Access Compliance Report

Public Rights-of-Way

(Curb Ramps)

Intersection ID: 15457	Main Street: EAST_BV	Cross Street: LOMBARDY_CR	Location: S
ADA ID: 9E1279E68408	Ramp Type: BlendTrans1	Initial Pass/Fail: Fail	Overall Compliance: No
Severity Score: 10			
Codes/Mitigation Info/Possible Solution		Field Measurements/Component Compliance

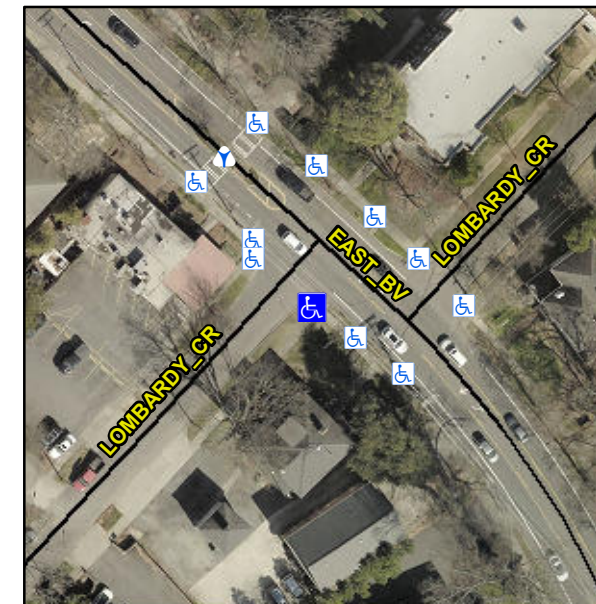
R304.5.1, R304.5.3

Compliance	Description	Data	Compliance	Description	Data
N/A	Ramp Length (in)	33.0	Yes	BlendTrans Slope (%)	1.2
No	Ramp Width (in)	42.0	No	BlendTrans XSlope (%)	3.6
N/A	Flare Type LT	N/A	N/A	Flare Type RT	N/A
N/A	Flare Slope LT (%)	N/A	N/A	Flare Slope RT (%)	N/A
N/A	Flare Traversable LT?	N/A	N/A	Flare Traversable RT?	N/A
N/A	Landing Length (in)	N/A	N/A	DWS Provided?	N/A
N/A	Landing Width (in)	N/A	N/A	DWS Contrast?	N/A
N/A	Landing Slope (%)	N/A	N/A	DWS Length (in)	N/A
N/A	Landing X Slope (%)	N/A	N/A	DWS Full Width?	N/A
N/A	Landing Curb? (Y/N)	N/A	N/A	DWS Offset (in)	N/A
N/A	Shared Landing?	N/A			
N/A	Gutter Ponding?	N/A	N/A	Gutter Slope (%)	N/A
N/A	Gutter Lip Ht (in)	N/A	N/A	Gutter X Slope (%)	N/A
N/A	Painted X Walk1?	No	N/A	Painted X Walk2?	No
	X Walk 1 Direction	To NE		X Walk 2 Direction	To NW
	X Walk 1 Width (in)	N/A		X Walk 2 Width (in)	N/A
	X Walk 1 Slope (%)	8.2		X Walk 2 Slope (%)	7.2
	X Walk 1 X Slope (%)	6.2		X Walk 2 X Slope (%)	1.3

N/A	Ramp inside XWalk1?	N/A	N/A	Ramp inside XWalk2?	N/A
	Road Slope (%)	0.5		Clear Space?	N/A
	Road X Slope (%)	9.8	N/A	Clear Space to XWalk (in)	N/A
N/A	Any Obstructions?	N/A	N/A	Storm Grate/Utility Hazard?	N/A
	Obstruction Type			Storm Grate/Utility Type	
		N/A			N/A
			Yes	Surface Condition? (G/P)	Good
			N/A	Curb Slope (%)	4.5

Remove & Replace Curb Ramp With Two New Directional Ramps or Equivalent.
